**ATCO Electric Yukon (AEY)  
2023-2024 General Rate Application (GRA)**

**Information Responses Round 1 to:  
The Yukon Utilities Consumers' Group (UCG)  
Received: September 6, 2023**

**AEY-UCG-085**

**Figure 1 - Whitehorse North 25kV System During Normal Operation**

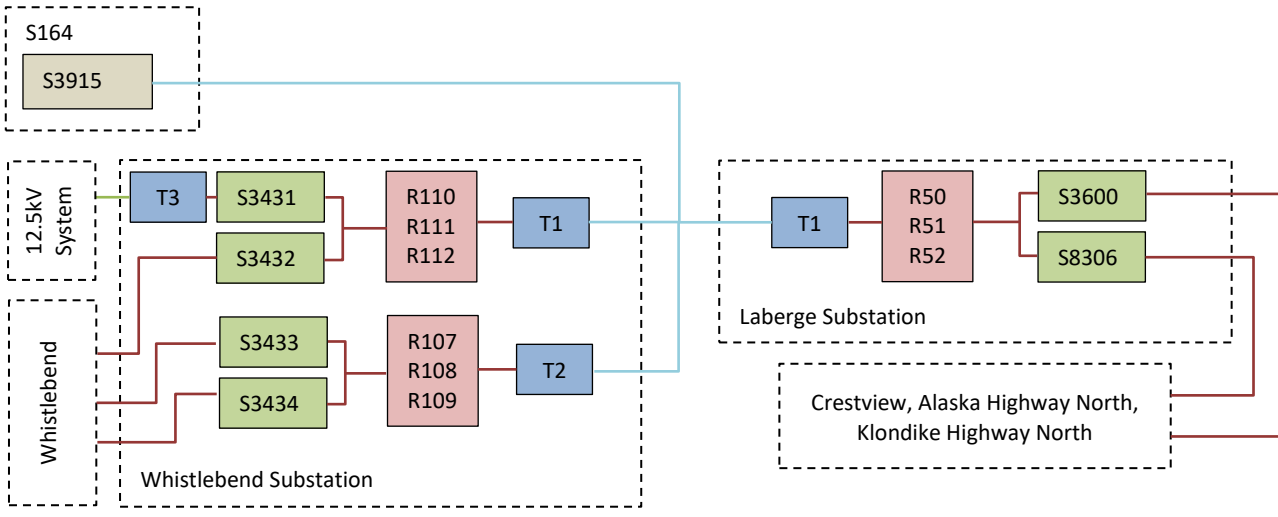
**Reference:** New Substations-Mayo Road and Whistle Bend, BC #25; Costs: Mayo Rd.- \$2.554million and Whistle Bend- \$2.781 million.

- (a) Provide engineering qualifications of what work was to be done for each project and what were the economic analyses identifying the business drivers and cost/benefits, including the preliminary engineering estimate of costs. Provide engineers report.

- (a) Please refer to the response to AEY-UCG-066(a). Please also refer to AEY-UCG-087(a) Attachment 1 - Whitehorse North 25 kV System Study Rev 2.0.

The Whitehorse North 25kV system has significant load growth expected over the next 5 years. At present, there is a contingency scenario that cannot be adequately addressed. As the load grows, substation regulator capacities will be exceeded, rural customer voltages will drop below acceptable levels and the number of failed contingency scenarios will increase. The projected load growth must be planned for and accommodations implemented to ensure continued safe and reliable operation of the Whitehorse power system.
